**TOWN OF CARMEL  
PLANNING BOARD**

**PLANNING BOARD AGENDA**  
**JULY 15, 2020 – 7:00 P.M.**

PROJECT NUMBER:  
0256  
DRAWING NUMBER:  
**C-020**  
SHEET 2 OF 24

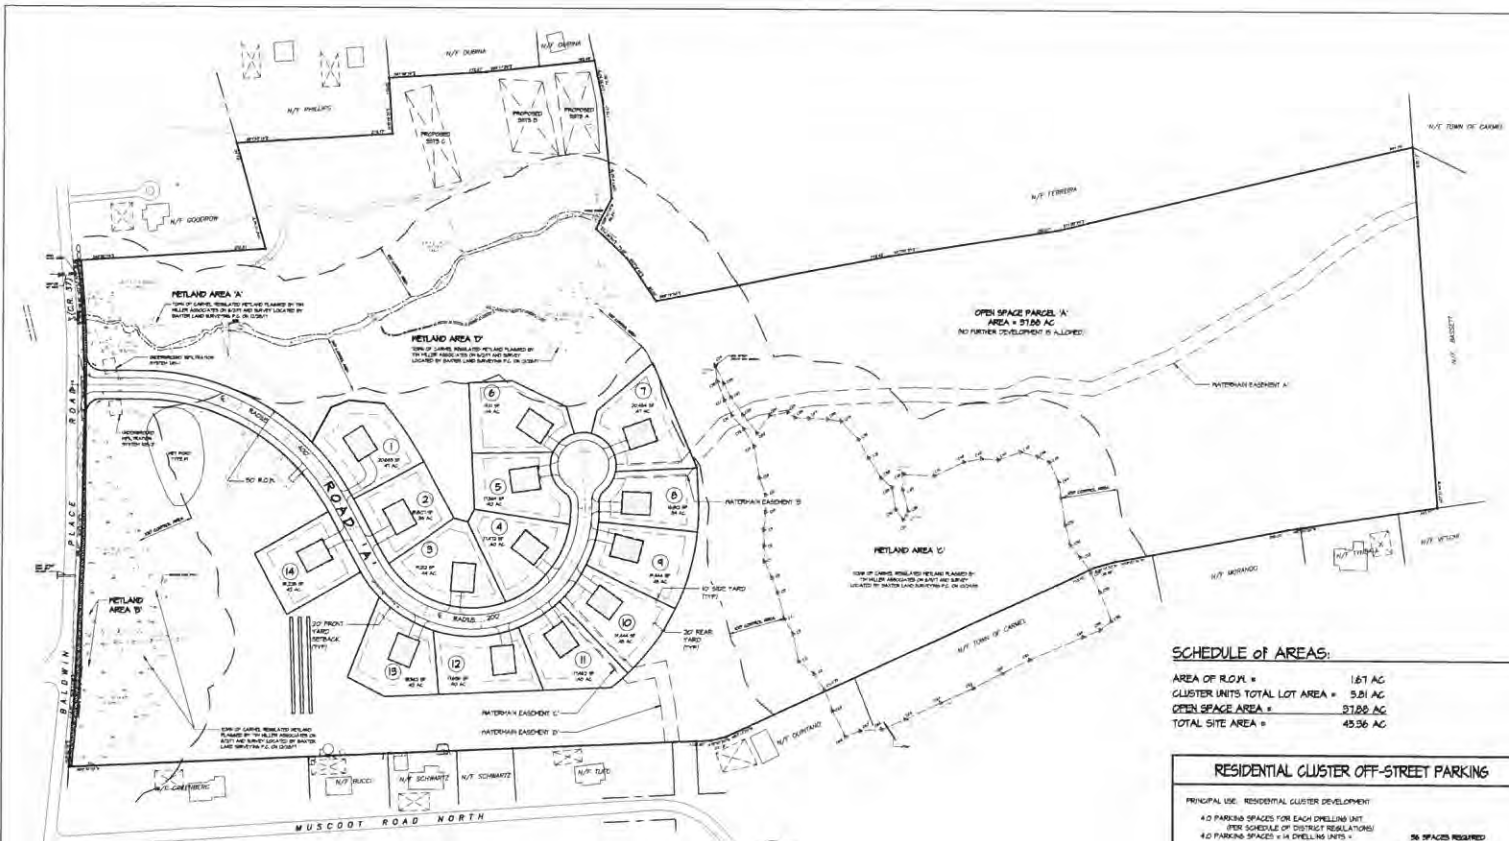
10. Drawing C-020 note 10 has been corrected.
11. Drawing C-120:
  - a. Additional catch basins have been added at station 11+77.5 and one additional basin at the cul- de- sac. (station 12+37 R)

PROJECT NUMBER: C-122  
DRAWING NUMBER: 8 OF 34  
SHEET 8 OF 34

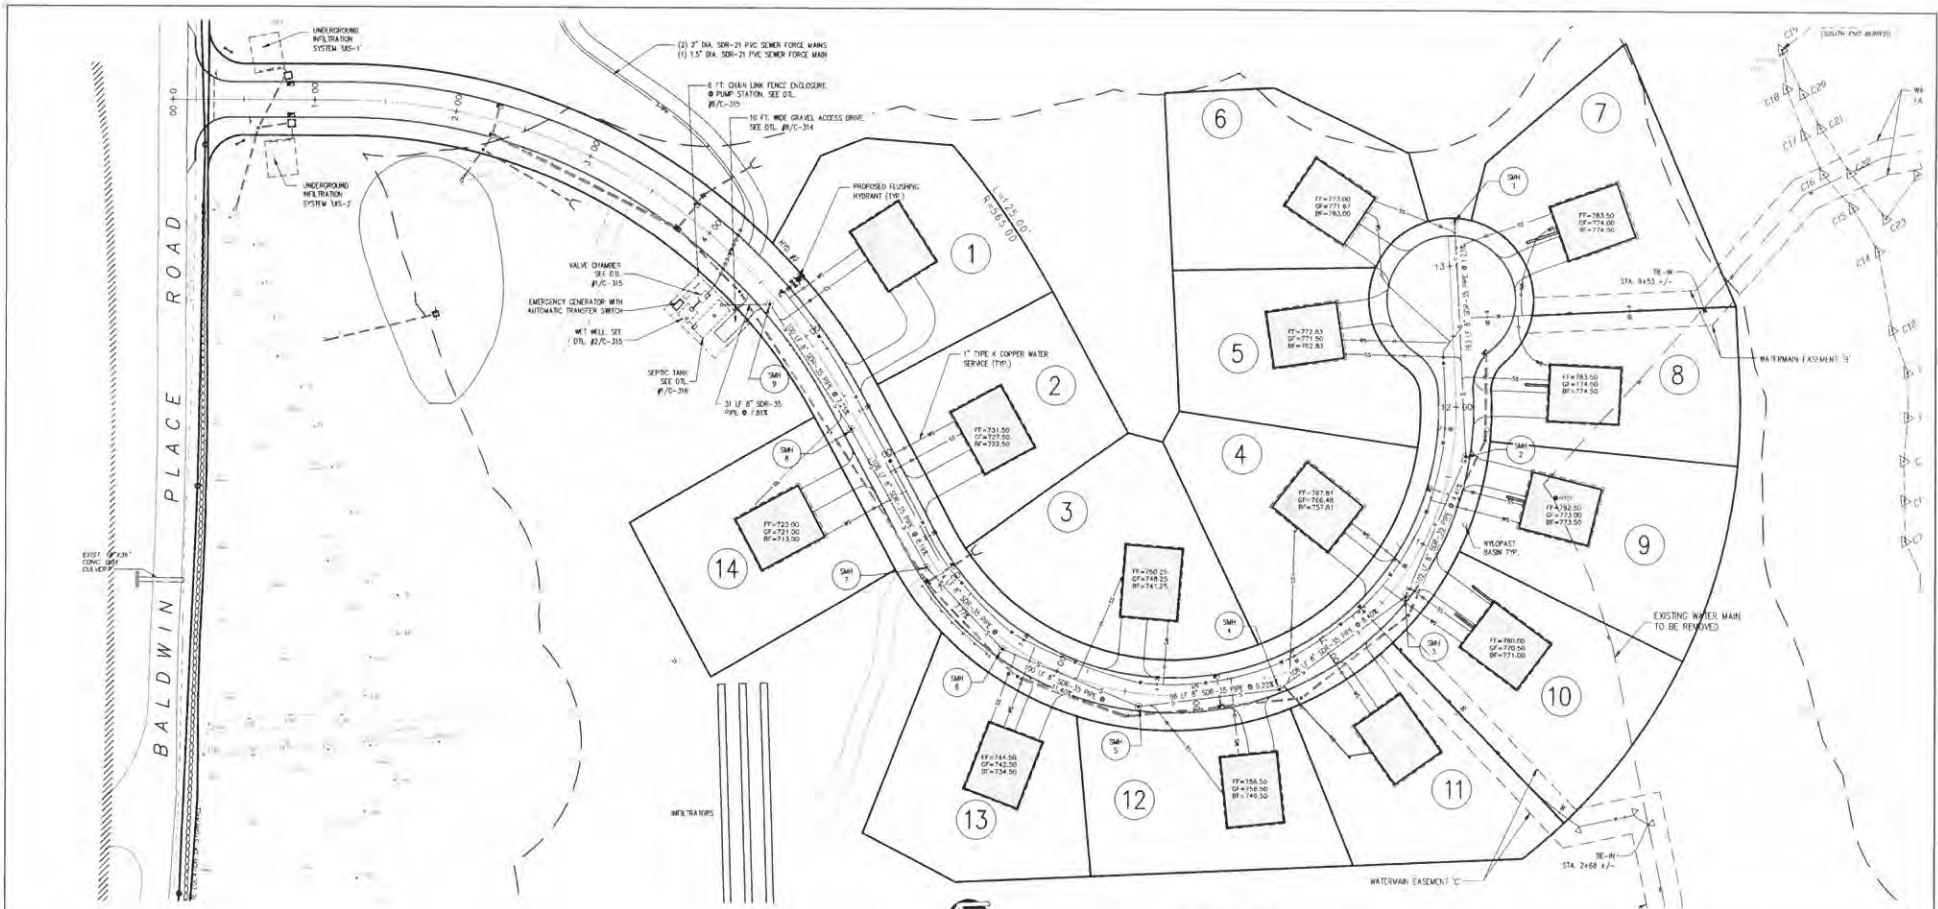
- b. Headwall #1 has been labelled.
  - c. The Flow Splitter (FS) has been removed as it is no longer required.
12. Drawing C-122 -footing draining for lots 2,9,10 and 11 have been clarified. They connect to the stormwater collection system.  
Footing drain for lot #2 will daylight at grade.

PROJECT NUMBER: 8326  
 DRAWING NUMBER: C-160  
 SHEET 32 OF 34

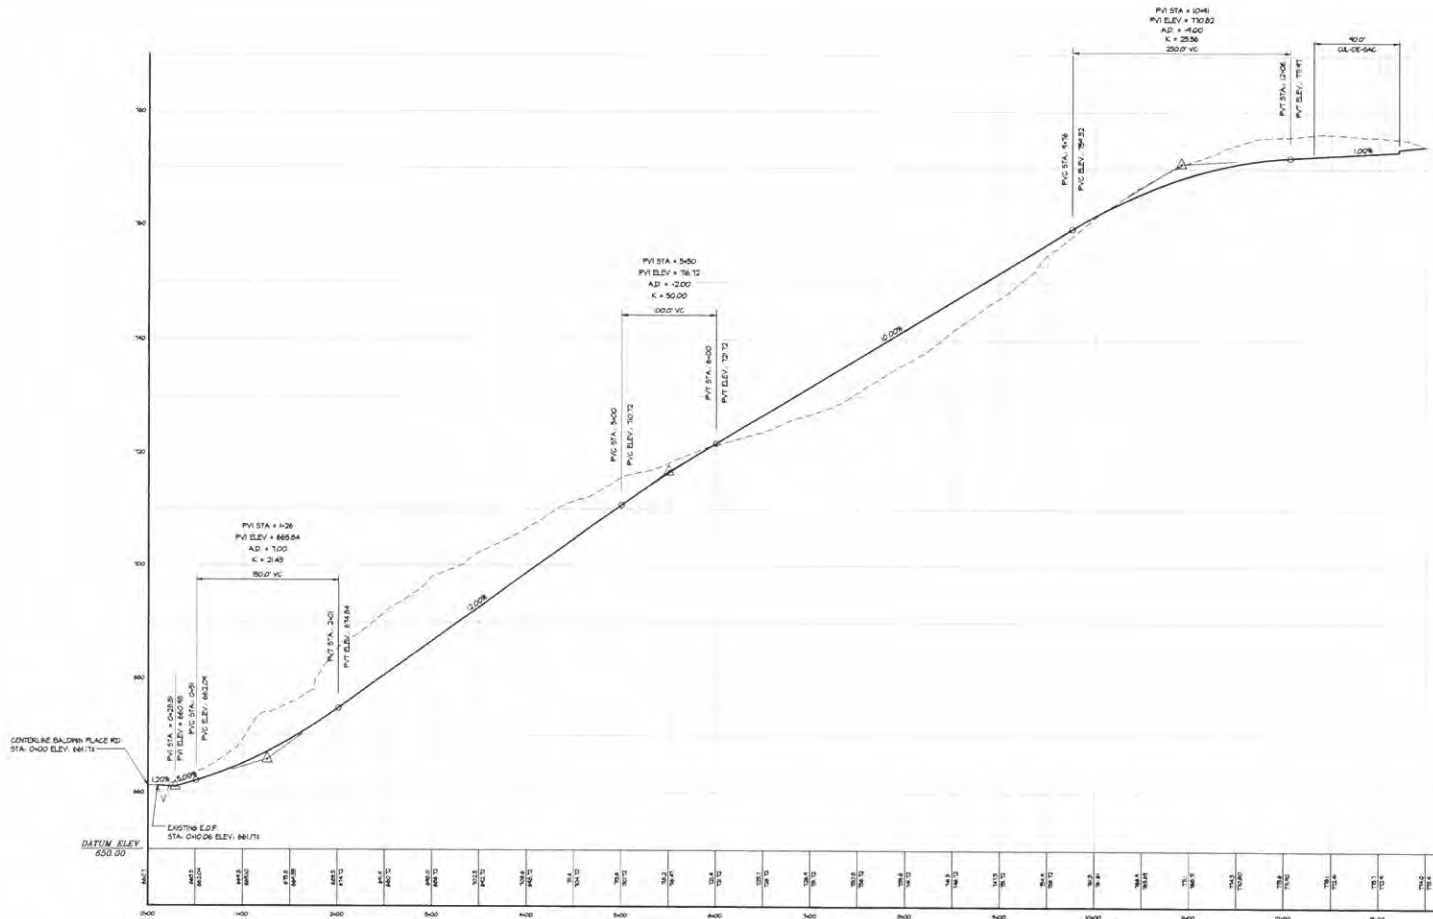
15. Drawing C-160 - Has been revised to reflect the 14 proposed rain gardens and the generic planting with quantities given.

PROJECT NUMBER: 0326  
DRAWING NUMBER: **C-410**  
SHEET 33 OF 34

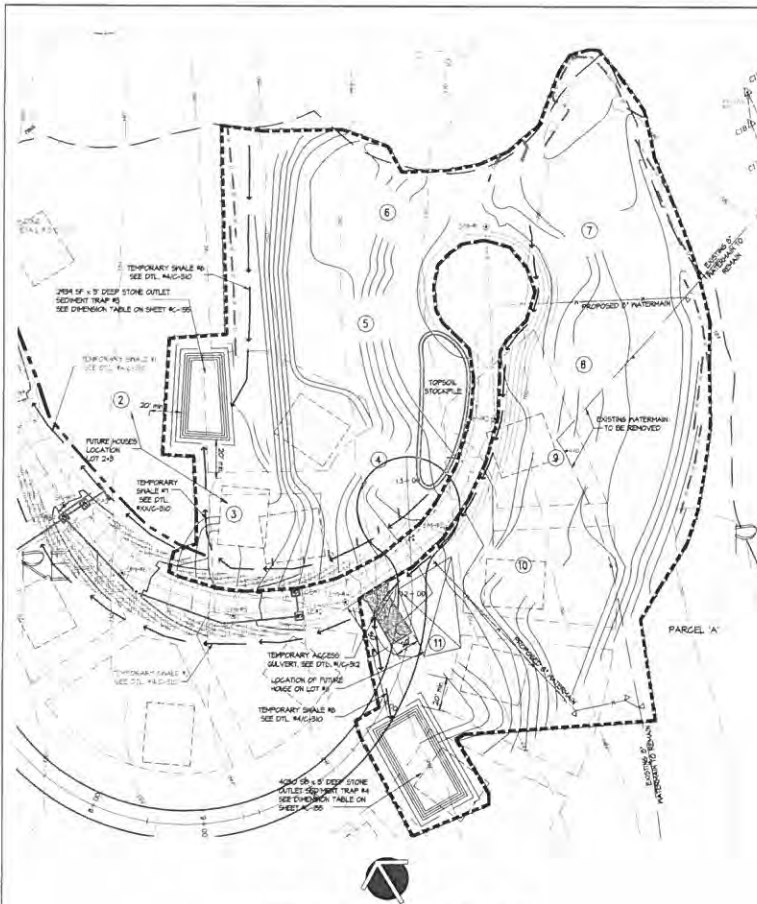
7. Every driveway with the exception of Lot 1 has a slope less than 5 percent (meeting code) for the entire driveway. Lot 1 has the first 20 feet at 3 percent (meeting code) and the last 30 feet at 3 percent also meeting code. Driveway profiles are all shown on Sheet 33 of 34.
